Hydrogeological Study
Halton Region
BURLINGTON
LANDFILL SITE
Continued Use

1984
EPA hearing

Project 83-55

Conductivity
 $\mu\text{ mhos/cm}$

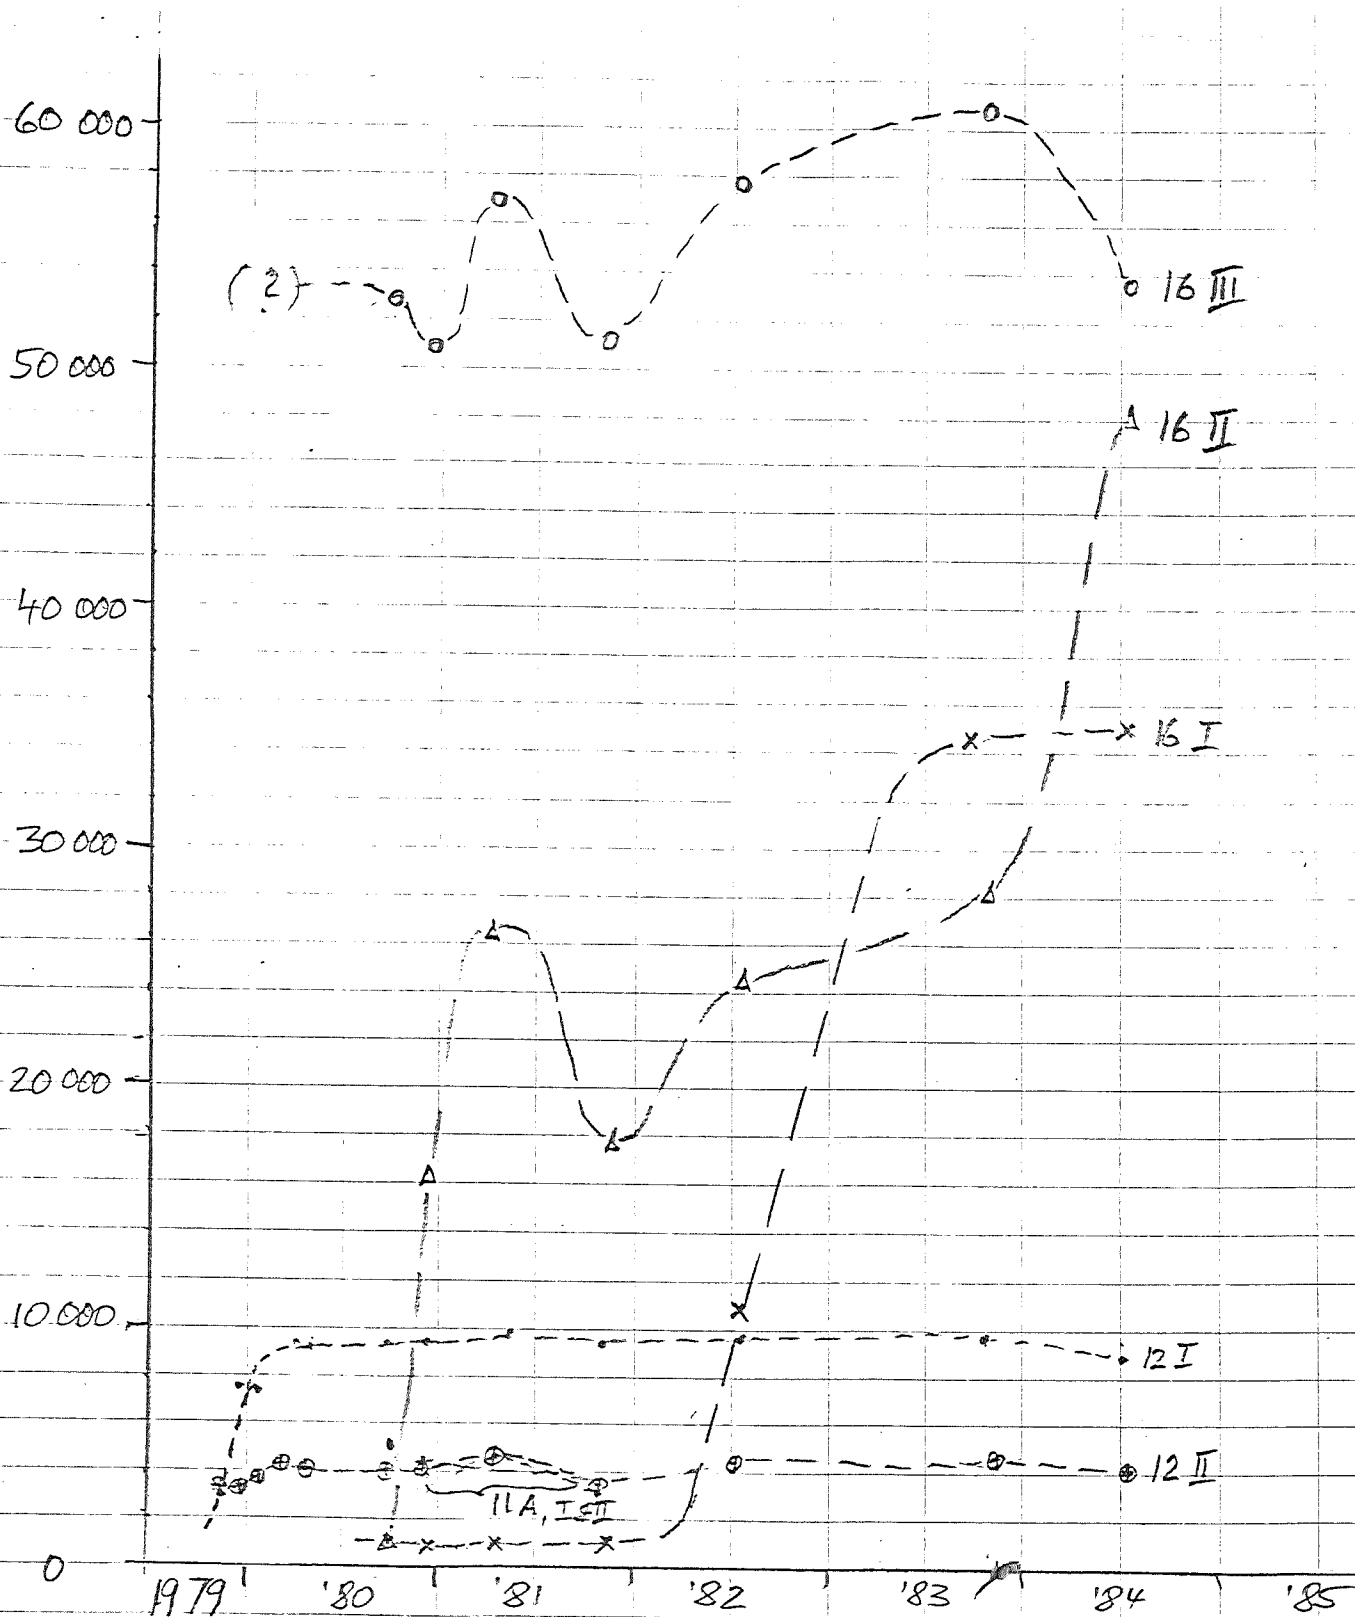
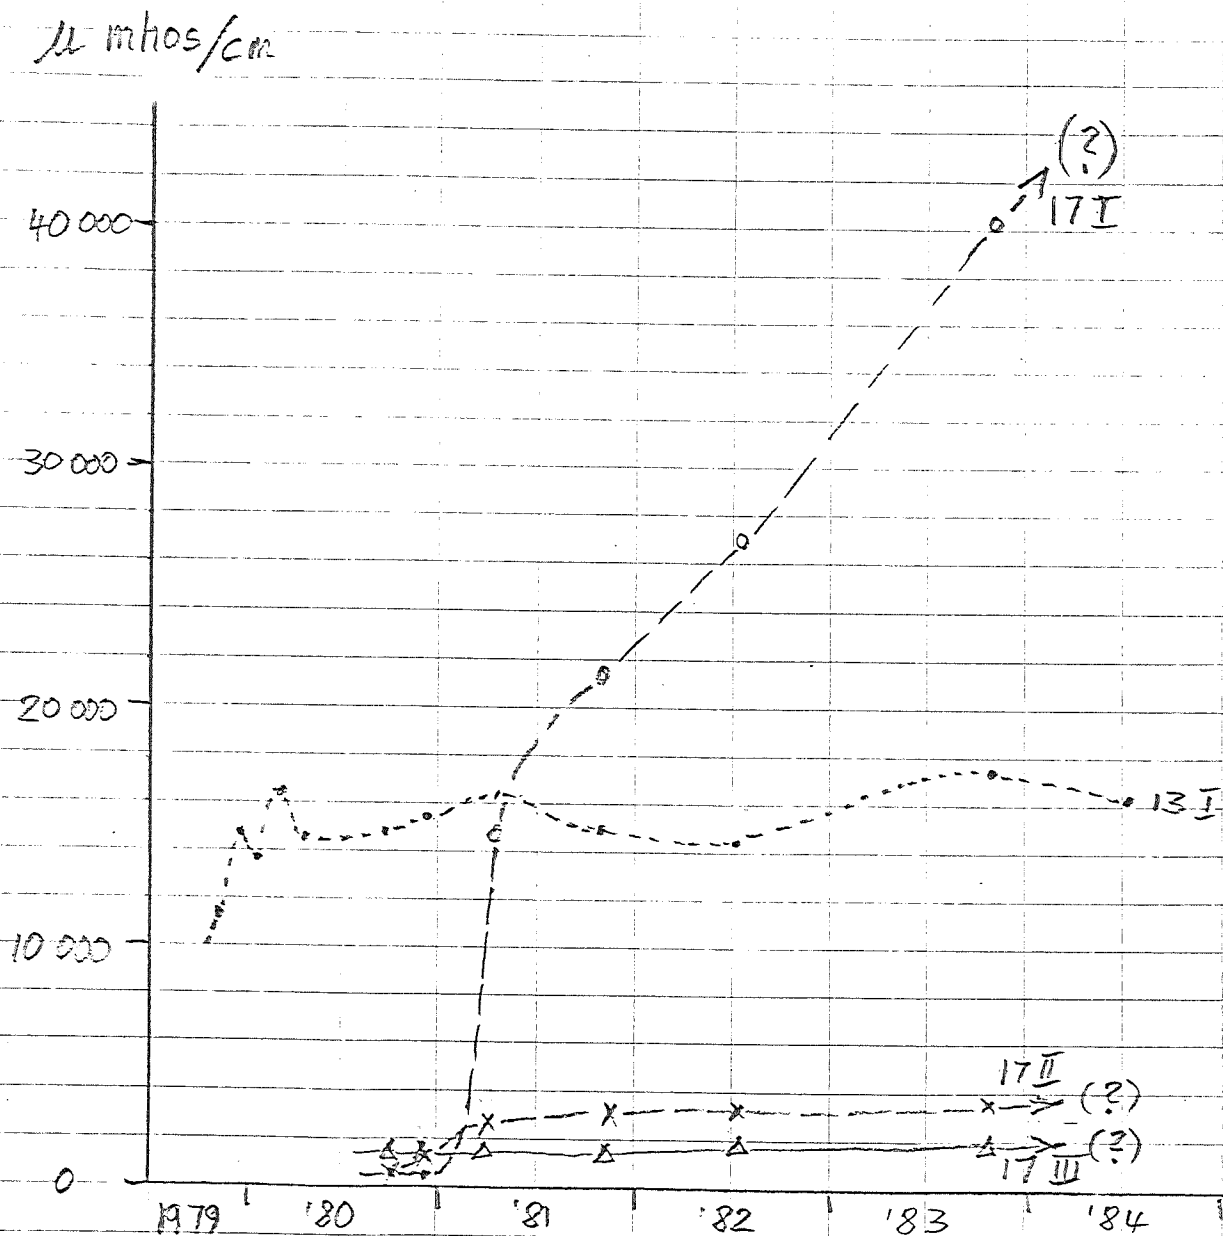
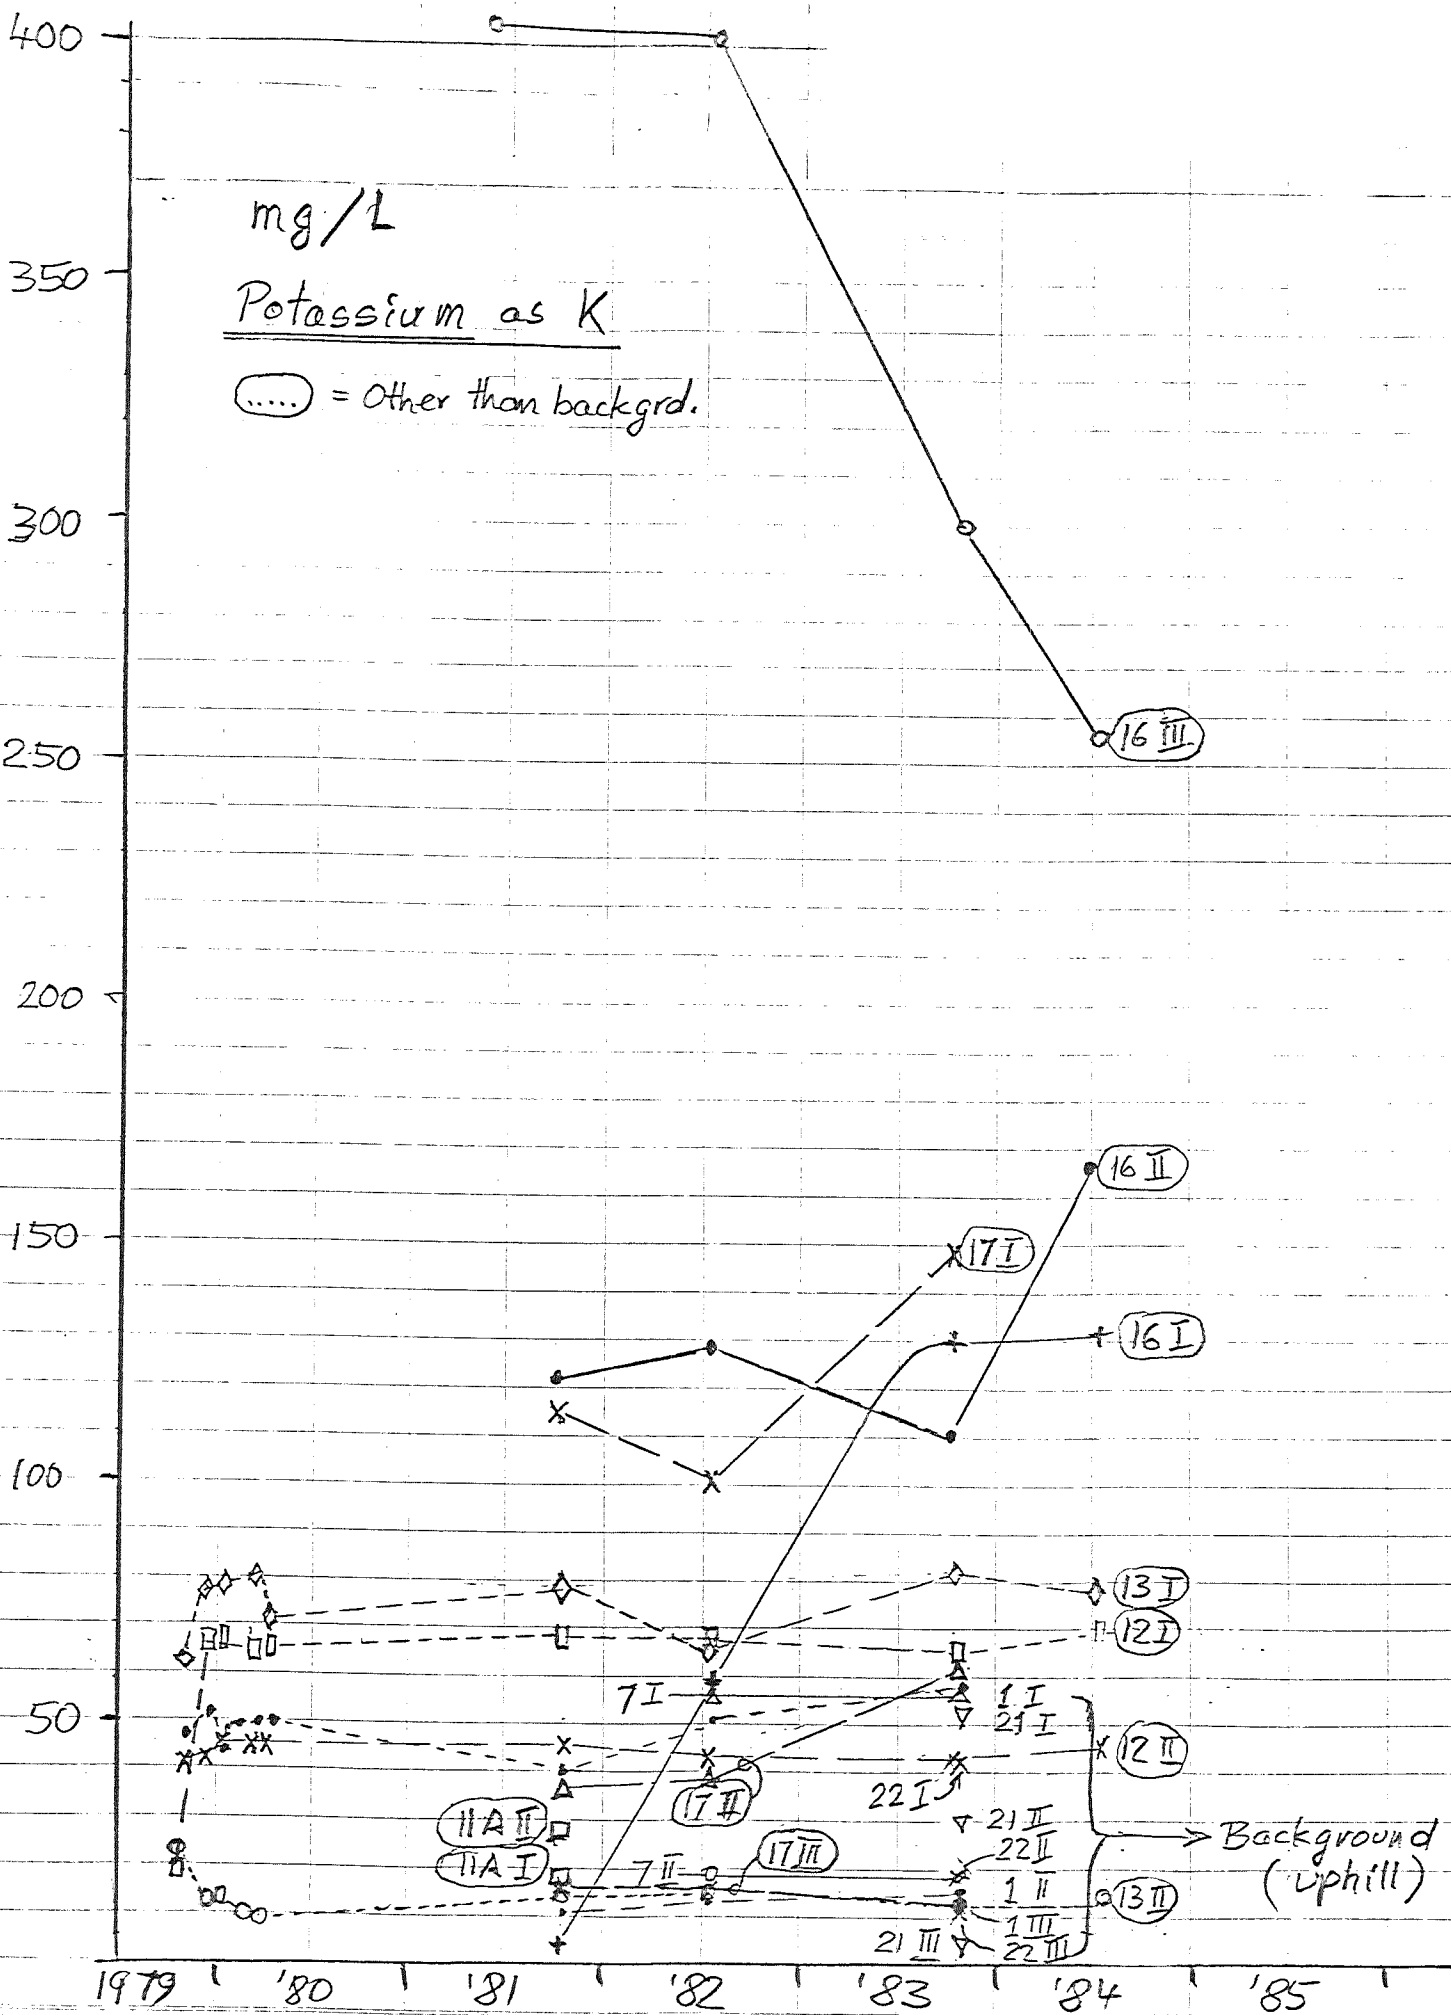
1. Completion of a credible Water Balance for the present regional landfill
2. Sufficient leachate analyses of samples from the midground wells as well as from the collection system to prove the completion of electrical neutrality.
3. Evaluation of the analyses of well samples (monitoring reports) and their concentration changes with time for plotting the progress of the concentration changes.
4. Review of piezometer well data and plotting of pressure profiles as they may have changed with time
5. Installation of two additional monitoring wells in the predominant downhill direction from the oldest part of the landfill, i.e. near the entrance road from N. Service Rd. to the weigh scale.

Chloride (Cl)
ppm

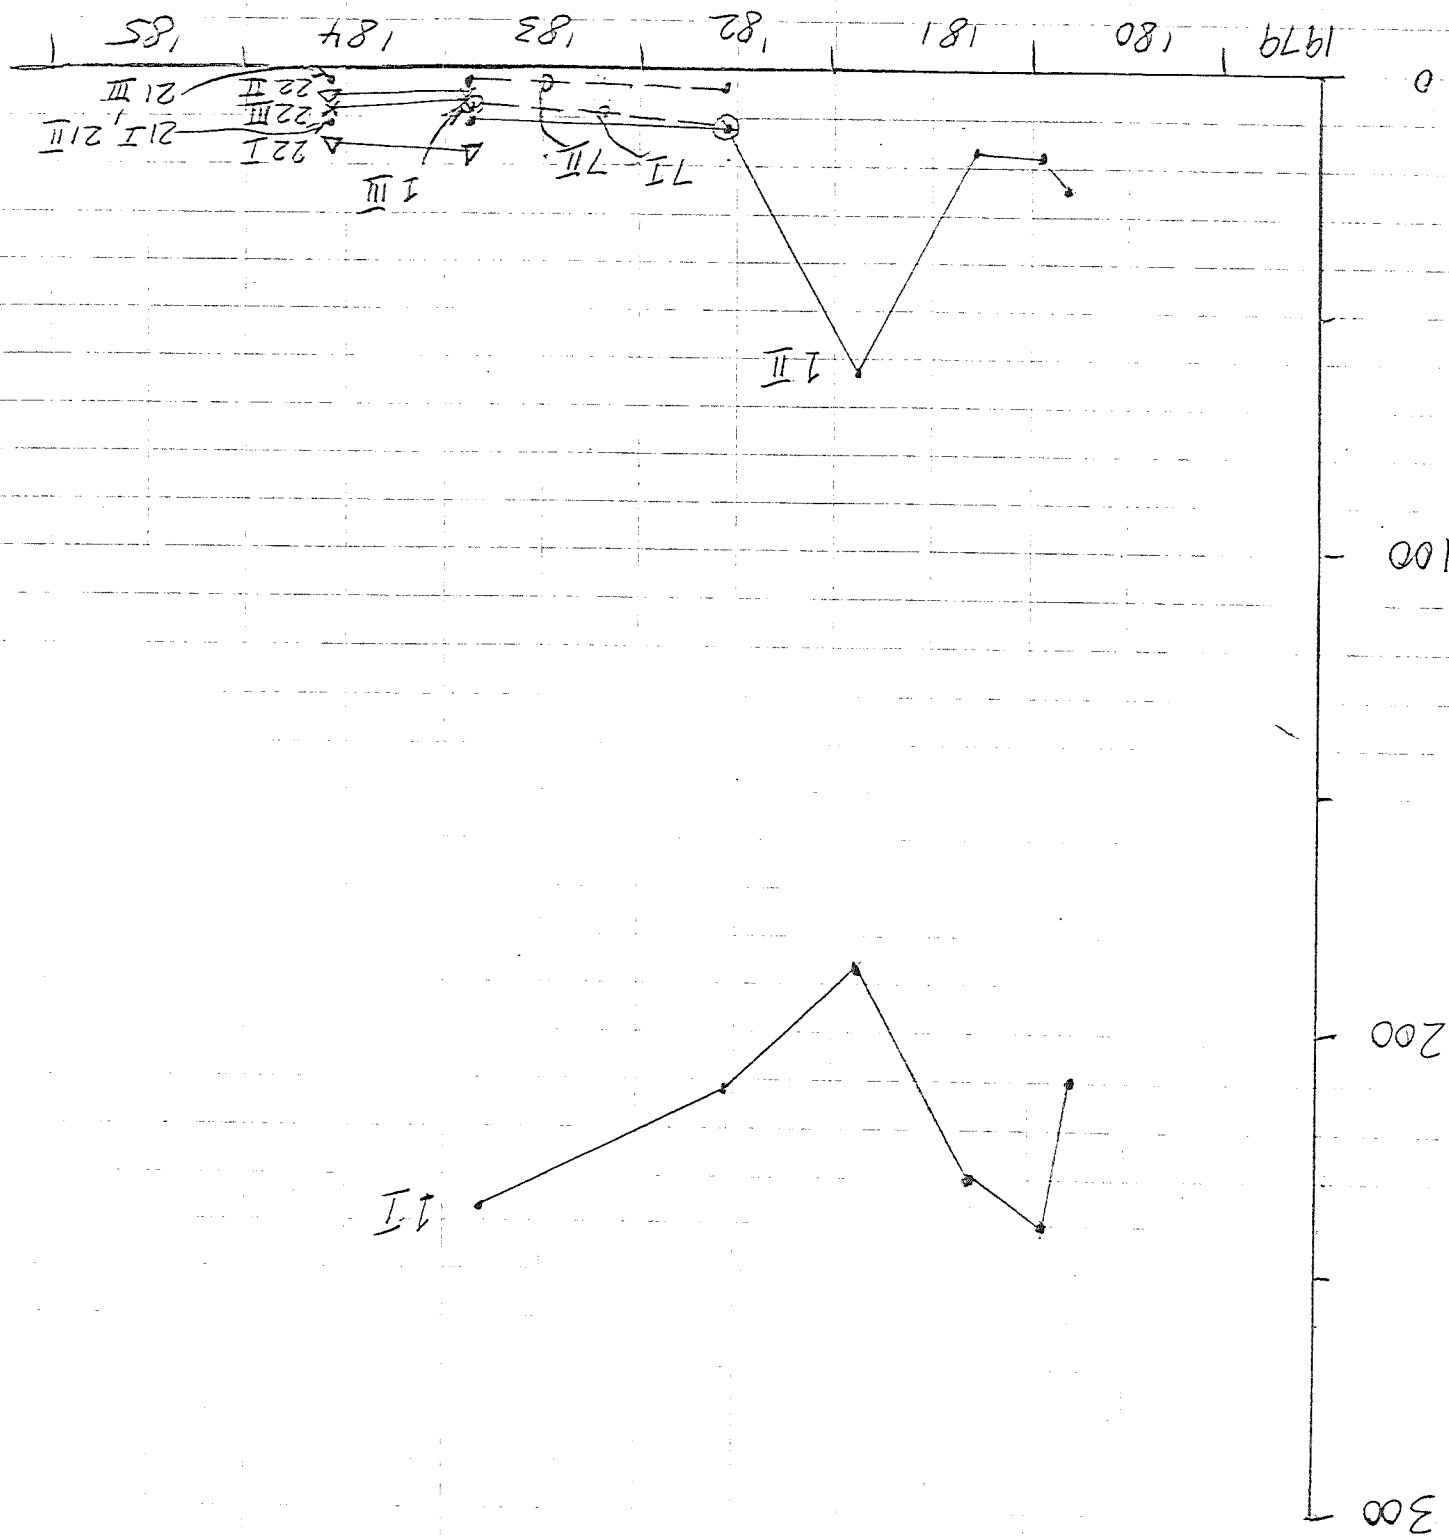
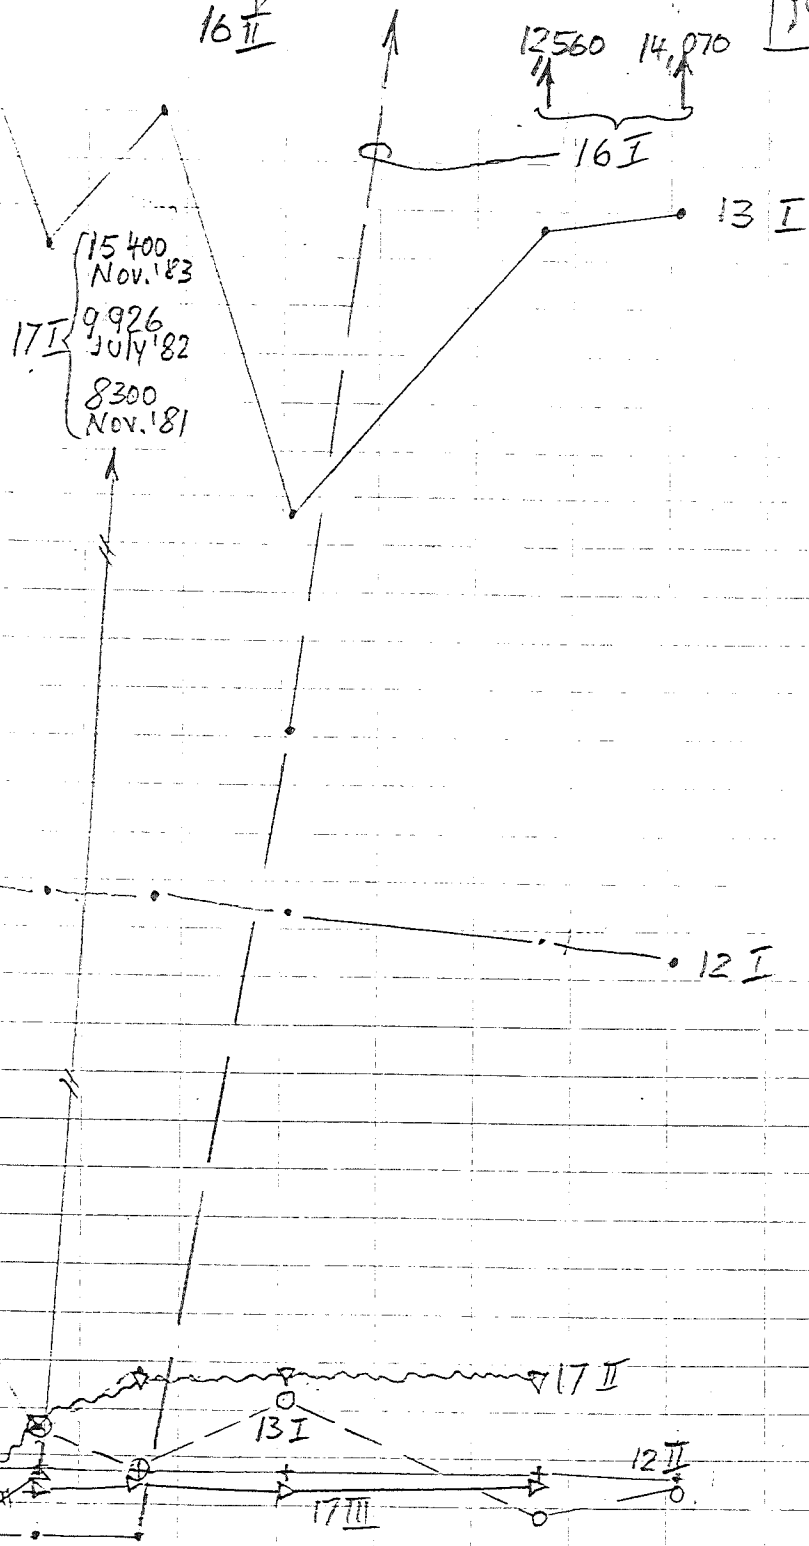
Also: 16 III
23,374 to 27,240
for Oct. '80 - July '84
